Petition Number: #2022-105

From: Jake Carpenter, PE Reviewer: Patrick Monroe

Date	Description		
11-28-22	First Review (PM)

Transportation Summary

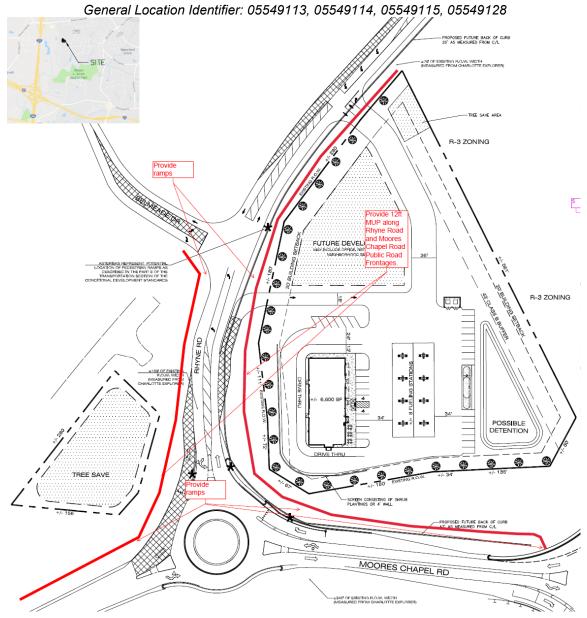
2. Revise site plan conditional note in the transportation section letter e. for Southbound I-485 Off Ramp to say, "Extend existing southbound right turn lane to provide 400' of storage and appropriate taper."

REWORD: iurisdiction.

Extend SBR to provide 400' of storage and appropriate taper. cted to

- e. Transportation mitigation improvements will consist of the following:
 - Southbound I-485 Off Ramp An addition to the southbound I-485 off ramp to provide 300' full storage plus taper (an extension of 100').
